Product Change Notification

Date Issued :	February 28, 2022	PCN Number :	511208
Reason for Change :	Change Supplier		
Description of Change :	<p>This notification is to inform you about change of supplier from Polyplastics to WOTE and resin LCP 30% GF BLACK& Natural UL94V-0 unchanged Reason:Polyplastics don't give Molex Shanghai any volume in CY22 Q2 due to capacity shortage, we need to qualify local LCP supplier Wote to meet ramp-up demand Impact: Resin 899920212 (POLYPLASTICS - LAPEROS E130I - BLACK) and 899920213 LCP 30% GF NATURAL UL94V-0</p> <p>Implement change: Validation of supplier change"</p>		
Reason for Short Notice :	Special Request		
Assessment of Change :	First Article Inspection		
Planned Implementation Date :	March 28, 2022		
Sample Availability Date:	March 10, 2022		
Internal Molex Qualification Date :	March 15, 2022		
Last date to request Samples by Customer :	March 20, 2022		
Traceability Code Markings / Date :	Date code

Product Picture

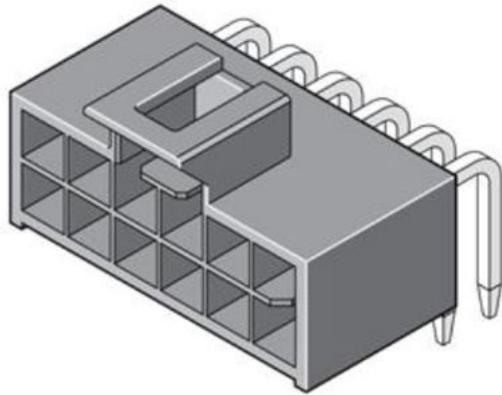
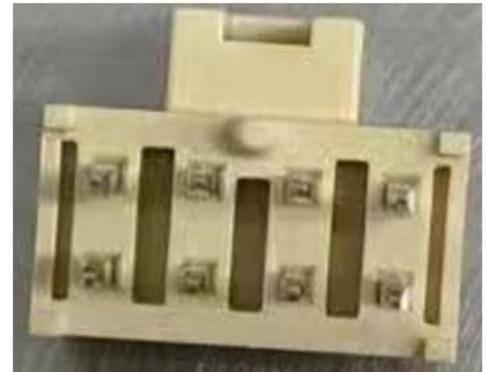
- Due to existing resin supplier Poly plastics capacity constraint issue, we must qualify second resin source to meet ramp-up demand. Current supplier Poly plastics don't supply any volume from CY22 Q2 due to their limited capacity. We must qualify local LCP supplier Wote to avoid production line-down, Wote is top one local LCP supplier in China.

- Product Impact
 - no impact to fit, form or function

- We only change LCP resin supplier but the resin LCP 30% GF BLACK & NATURAL UL94V-0is not changed
 - ✓ Before: Polylactics LCP E130i
 - ✓ After: Wote LCP KD130i
